TO: Chairman Oz Nesbitt, Rockdale County
ATTN TO: Kalanos Johnson, Director Planning and Development, Rockdale County
FROM: Mike Alexander, Director, ARC Center for Livable Communities
RE: Development of Regional Impact (DRI) Review

Name of Proposal: Preserve at Honey Creek DRI 3450

Description: A DRI review of a proposal to construct 620 single-homes on a 286 acre site off of Honey Creek Road in Rockdale County. The site is currently mostly wooded with a lake and several streams.

CONCEPT PLAN

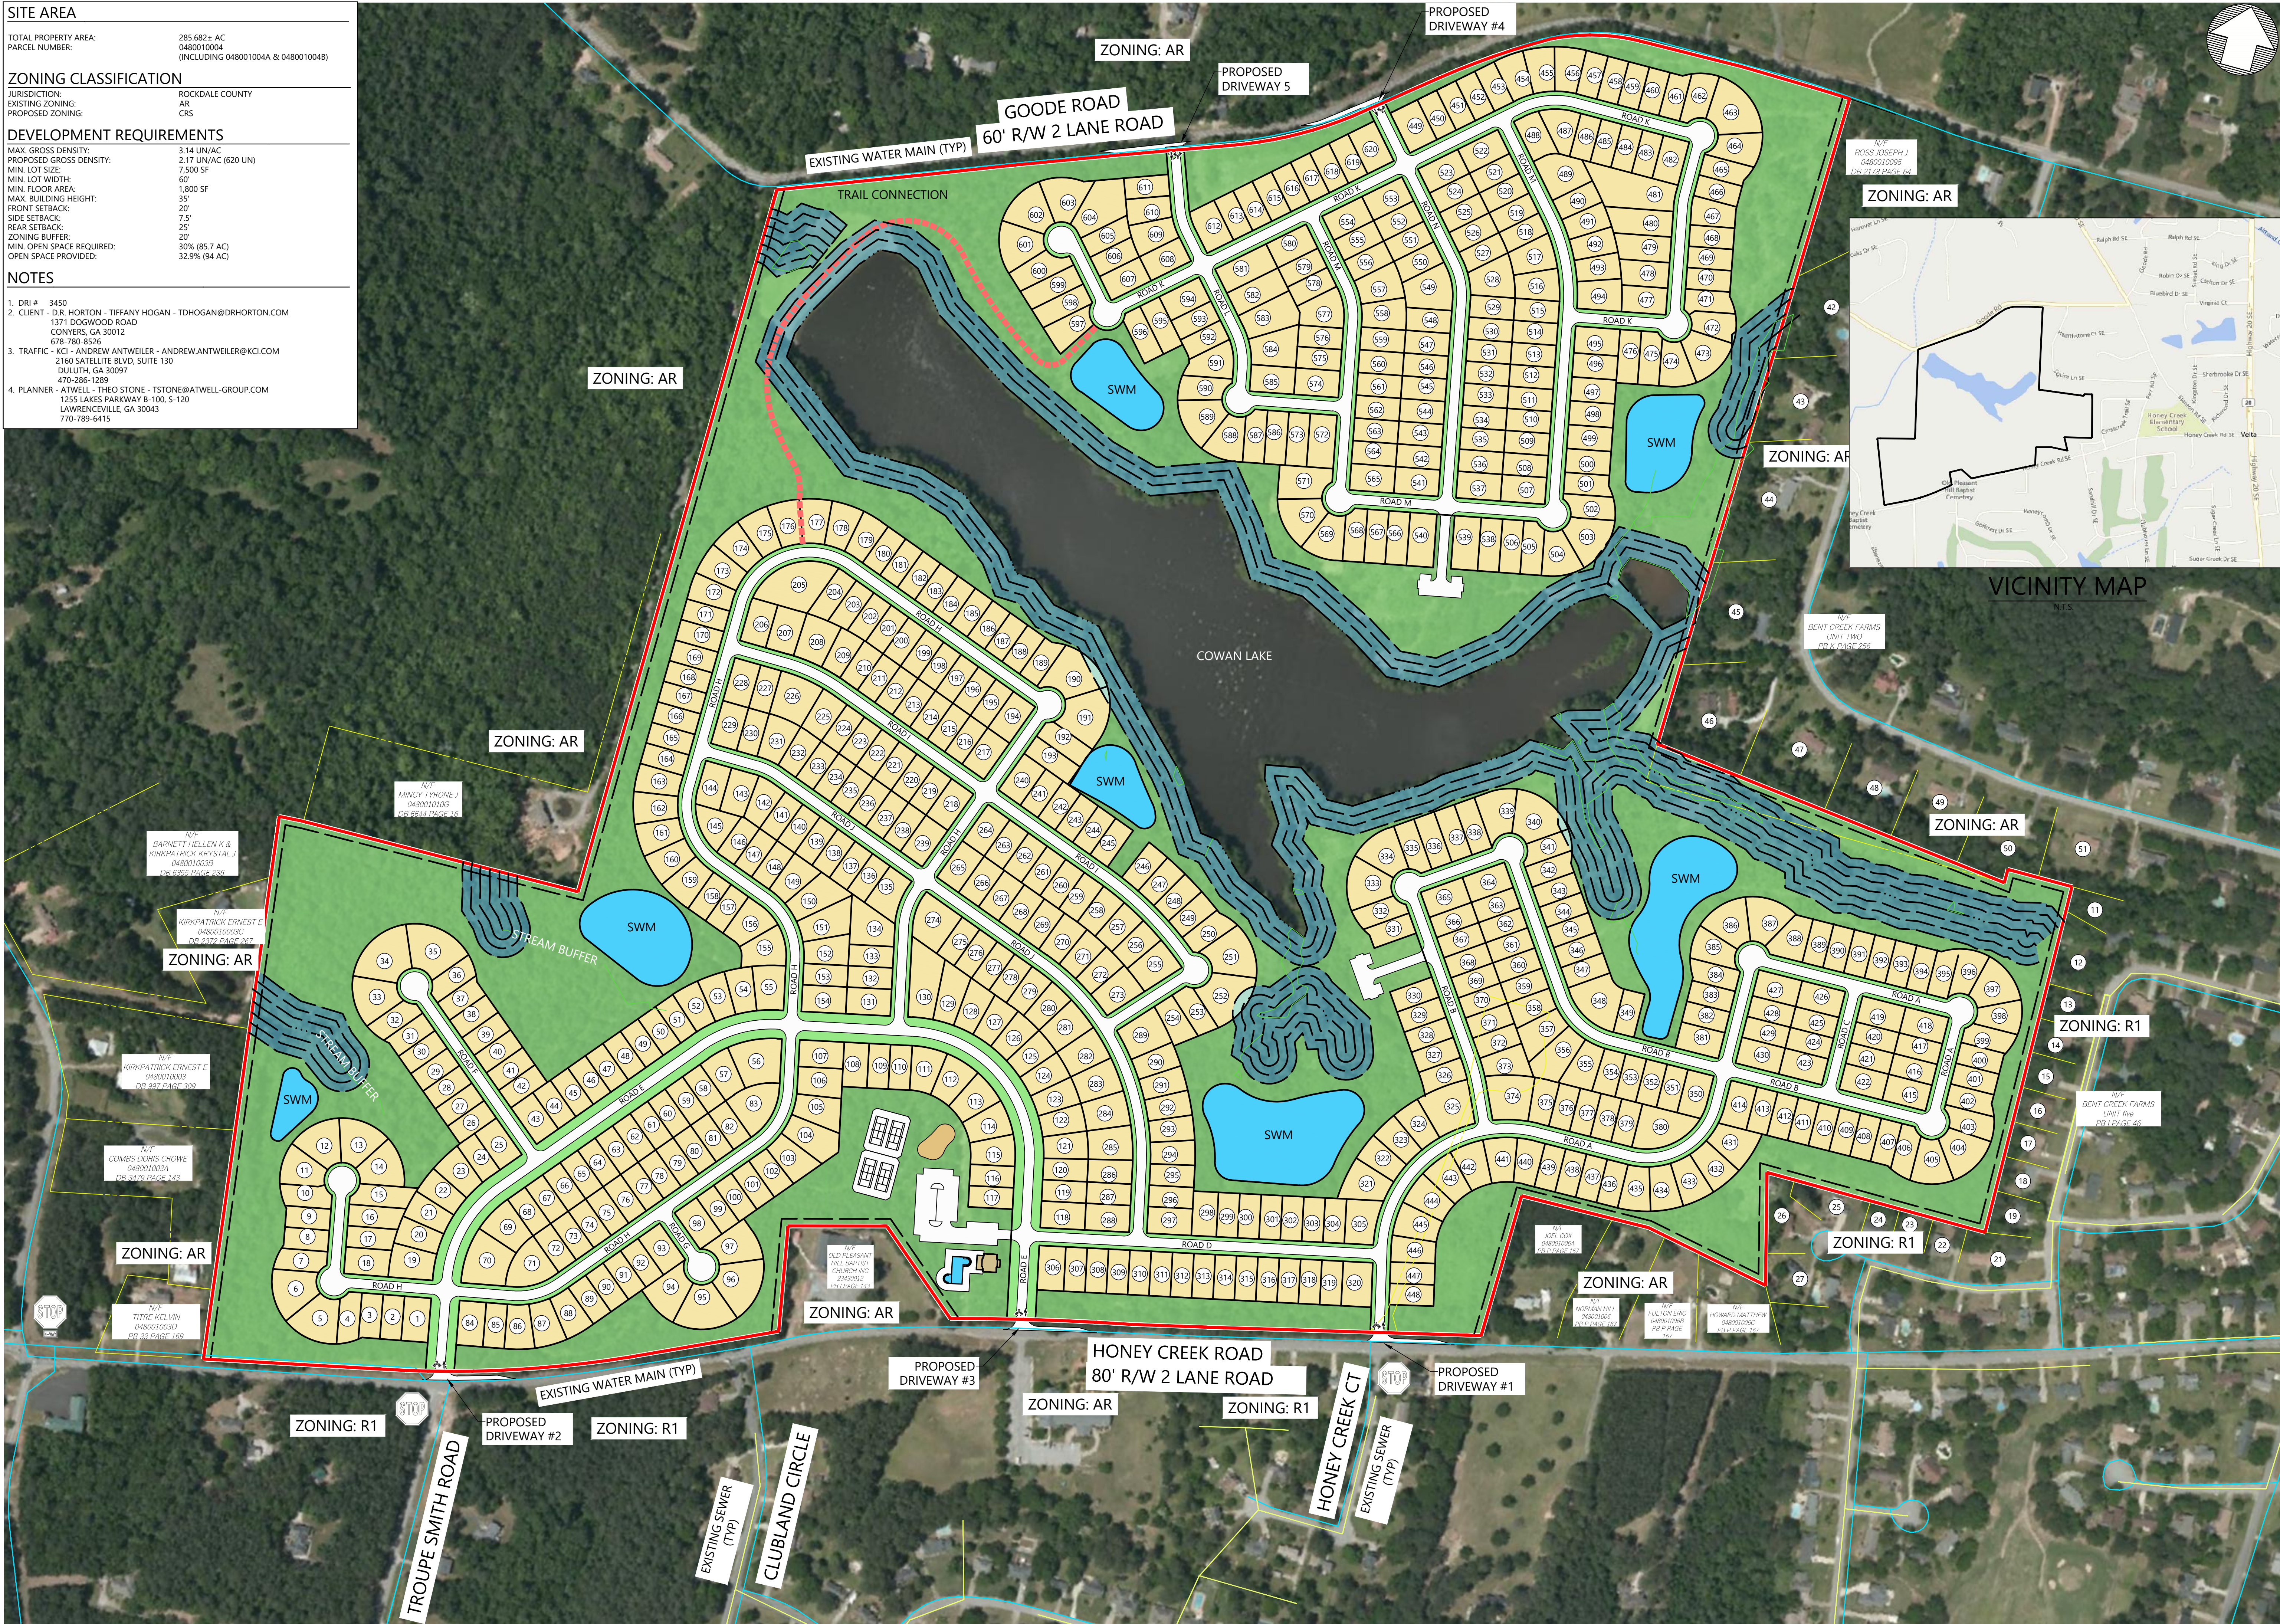
Several streams are shown on the site plan with what appears to be the required buffers; these buffers should be clearly labeled to facilitate review. Development appears to intrude into the buffers at several locations, including the trail at the NW corner of the site, which may require a variance.

The proposed trail in the NW area of the project (which may need to be adjusted to accommodate the adjacent stream buffer) is supportive of regional multi-modal transportation and connectivity goals; additional similar trail connections where possible would further support these goals.

It is not clear from the site plan if the project will include an internal sidewalk system. A basic sidewalk system, ideally connecting to sidewalks along Honey Creek Road leading to the Honey Creek Elementary School just a few blocks from the site, would be supportive of regional multi-modal transportation policies.

It is not clear from the site plan if the project will include an internal sidewalk system. A basic sidewalk system, ideally connecting to sidewalks along Honey Creek Road leading to the Honey Creek Elementary School just a few blocks from the site, is considered a fundamental transportation and mobility requirement for all new developments in the region. The proposed walking trail connecting the north and south sections of the project is supportive of regional transportation policies; the provision of additional trails would be even more so.

The USGS coverage for the project area shows streams at either end of Cowan Lake as well as an intermittent stream flowing into an unnamed tributary of Honey Creek. The submitted site plan shows these streams on the property as well as four other stream segments shown on the property. Although not identified, with no legend on the plans, buffers that appear to be the County 50-foot undisturbed buffer and 75-foot impervious setback, as well as the State 25-foot Erosion and Sediment Control buffer are shown on all streams as well as Cowan Lake. The only intrusion shown on the plans is a trail crossing one end of Cowan Lake. The trail is subject to the requirements of the County and State buffers and may require a variance. Any unmapped streams on the property may be subject to the Rockdale Buffer ordinance. Any unmapped streams and waters of the state on the property are also subject to the State 25-foot Erosion and Sediment Control Buffer.
